NEW FEATURES

1GR-FE ENGINE

■ FUEL

07D7EG01TE

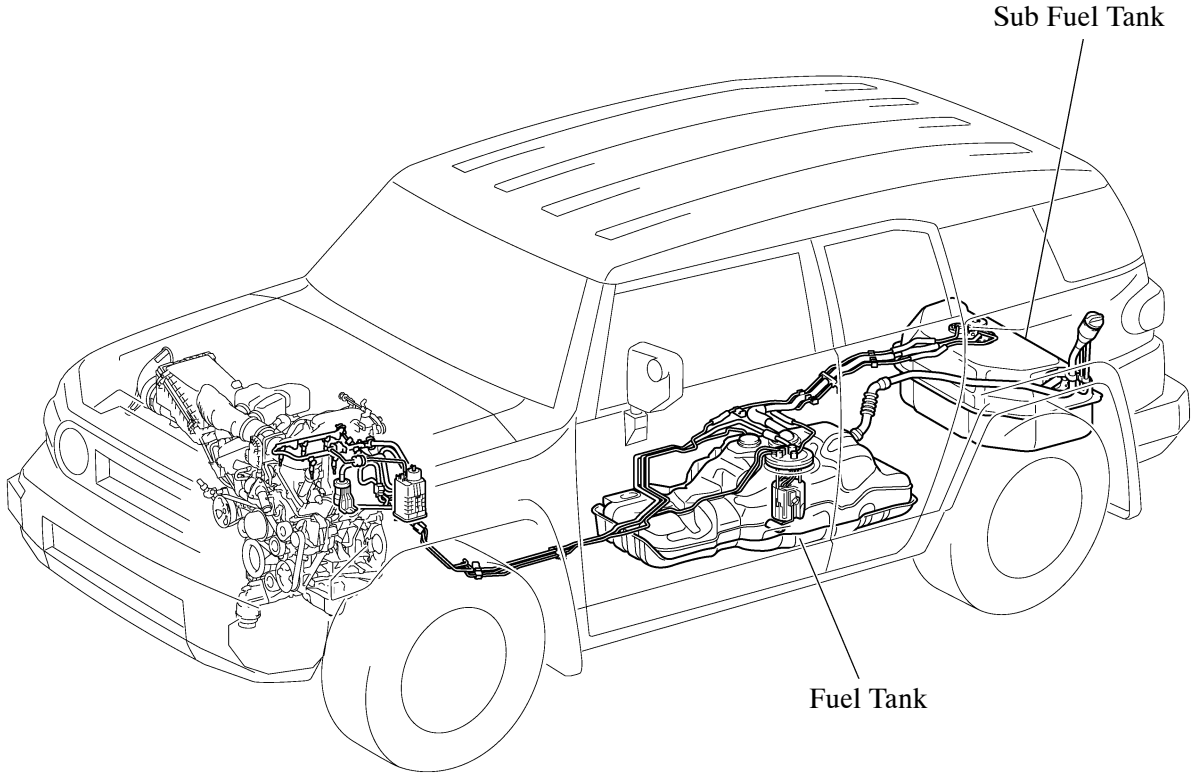
A sub fuel tank to be installed under the rear floor has been available as optional equipment.*

Vehicle running distance has been extended drastically by installing an optional sub fuel tank that increases the tank capacity from 72 liters to 159 liters.
